Name: Morné de Jager
Cell: 082 565 4059
E-mail: morne@menco.co.za
Date: 22 June 2021
Ref: Komsberg East WEF

SPECIALIST OPINION: PROPOSED KOMSBERG EAST WIND ENERGY FACILITY PART II AMENDMENT

The above-mentioned issue as well as reports AC-KWF/ENIA/201510-Rev 0 (original report) and AC-KWF/A-ENIA/201603-Rev 0 (report evaluating an updated preferred layout) is of relevance.

Figure 1: Locations of wind turbines as considered in this letter of opinion

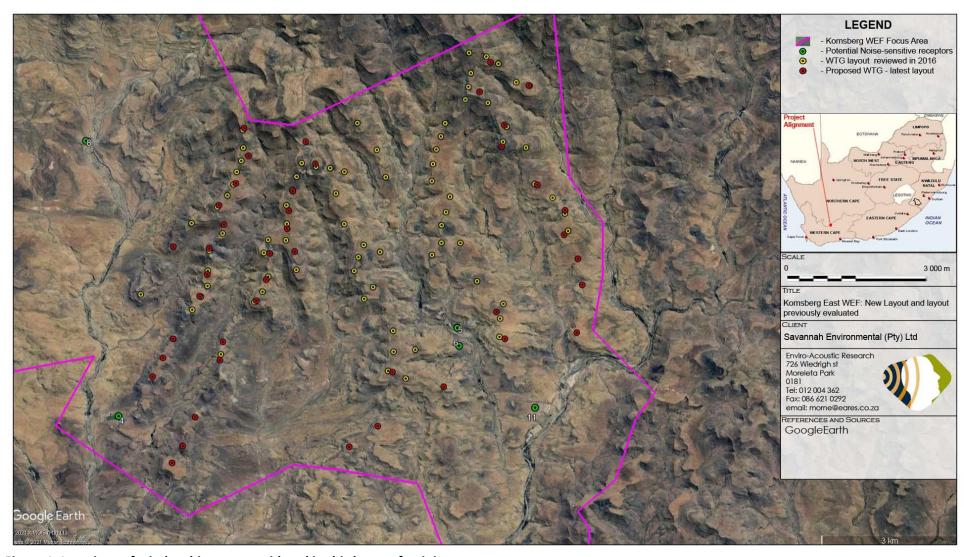
The developer of the Komsberg East Wind Farm has since optimized the layout (See also **Figure 1** for the new layout) of the wind farm, locating the wind turbines at optimal locations and changing the WTG specifications.

Five (5) WTGs within 2,000 m from NSD04, though no WTG are closer than 1,000 m from this receptor; Four (4) WTGs within 2,000 m from NSD05 and 06, with one WTG just closer than 1,000 m (± 920 m) from NSD05 and one WTG just closer than 1,000 m (± 950 m) from NSD06.

The layout will increase the noise level at NSD04, though the level should be less than 42 dBA. The layout will decrease the noise level at NSD05 and 06, with the noise level less than the noise level previously calculated these receptors (less than 42 dBA).

- in terms of statement 1 (section 7.3.2 of the Addendum Report, AC-KWF/A-ENIA/201603-Rev 0), the proposed changes do not introduce new wind turbines closer than 1,000 m from an identified NSD (the new layout reduce the WTGs).

- the change will not increase the significance of the noise impact at NSD04 (while the noise level will increase, the noise level will be low and less than 42 dBA), subject that a wind turbine with a maximum sound power emission level of 108.4 dBA are used by the developer;

- the change will not increase the significance of the noise impact at NSD05 and 06 (the noise level will reduce), subject that a wind turbine with a maximum sound power emission level of 108.4 dBA are used by the developer;

If the developer selects a wind turbine generator with a sound power emission level exceeding 108.4 dBA, the noise impact assessment must be reviewed in detail. Should you require any further details, or have any additional questions, please do not hesitate to call me on the above numbers.
